March 20, 1992
Fort St. Vrain
Unit No. 1
P-92123

SUBJECT: ENVIRONMENTAL REPORT SUPPLEMENT FOR
DECOMMISSIONING -- RESPONSE TO REQUEST FOR
ADDITIONAL INFORMATION

SUPPLEMENT TO APPLICANT'S ENVIRONMENTAL REPORT
POST OPERATING LICENSE STAGE, FOR FORT ST. VRAIN
DECOMMISSIONING

PSC RESPONSE TO NRC REQUEST FOR ADDITIONAL INFORMATION

FIGURE T-1

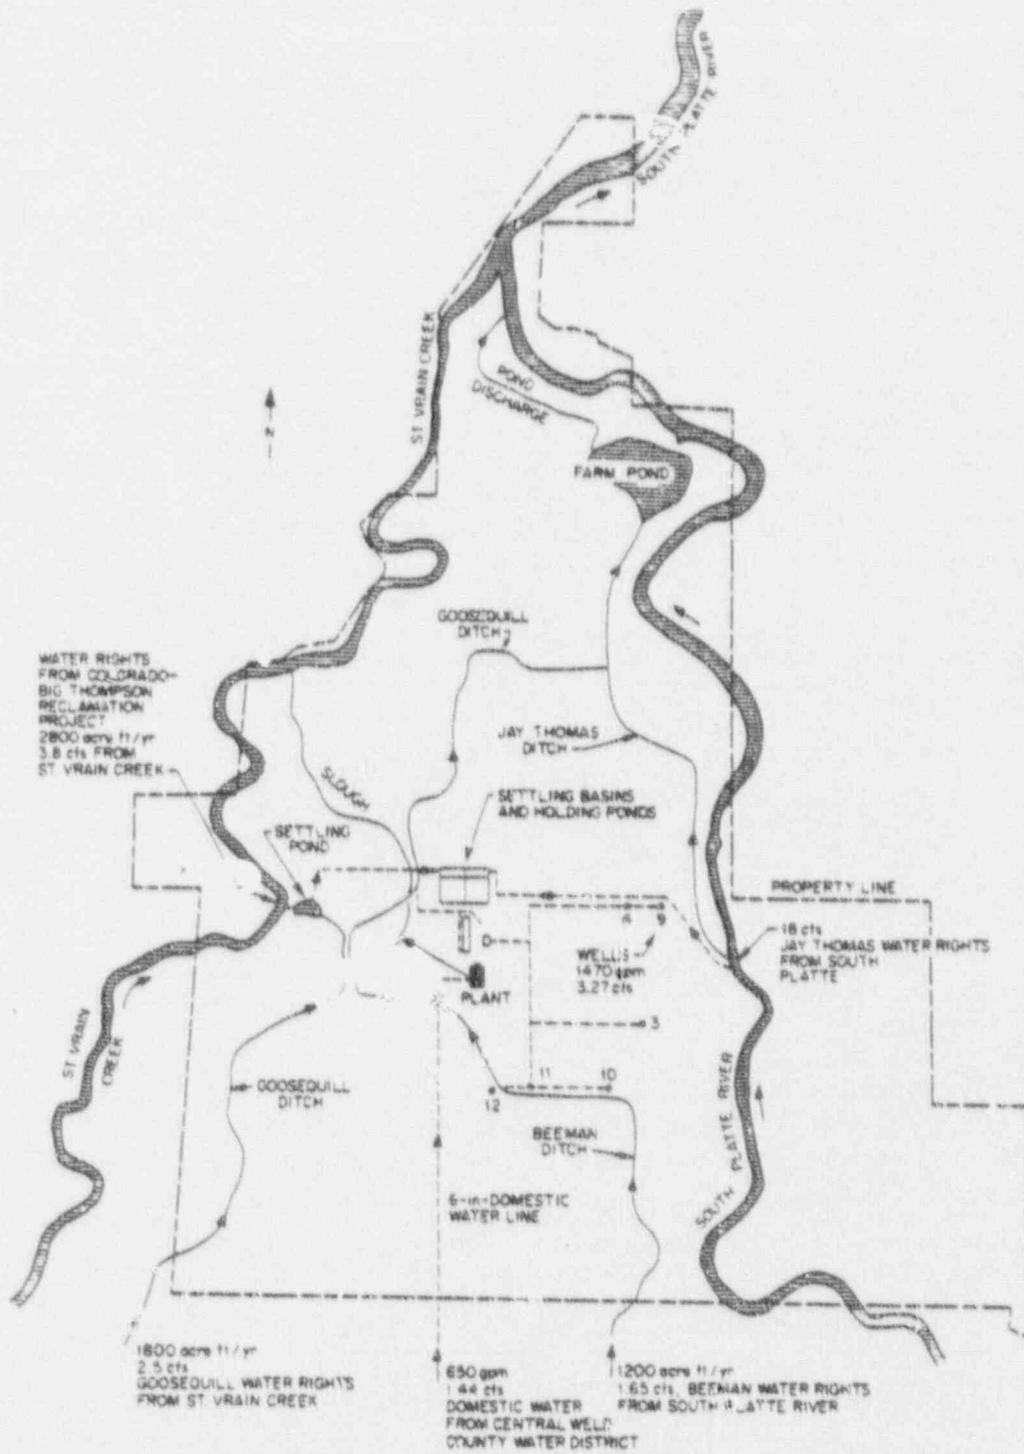
From page 4-4 of the ER Supplement, you state that "the use of surface water from the site is limited almost entirely to irrigation." The NRC cannot make an assessment of the relationship to water usage for irrigation purposes and that for public water supply (see Table 4.1-1), based on the information provided. While the tritiated water flow rates may not be viewed as radiologically significant (there is a stated commitment to meet 10 CFR Part 20), it is nevertheless important to assess the potential pathways (for example, location and species of fish and the crops irrigated).

The same liquid effluent release path will be used during decommissioning as was used during normal plant operations. As shown in Figure T-1 (which is similar to Figure 4.1-5 of the Environmental Report Supplement, Reference 5), diluted liquid effluent will normally be released from the FSV protected area to the Goosequill Ditch. From the concrete lined Goosequill Ditch, liquid effluent then flows into the Jay Thomas Ditch, where additional dilution may occur, and then on to a 25 acre farm pond that contains about 32 million gallons of water. Water flows approximately 8700 feet from the plant to the farm pond.
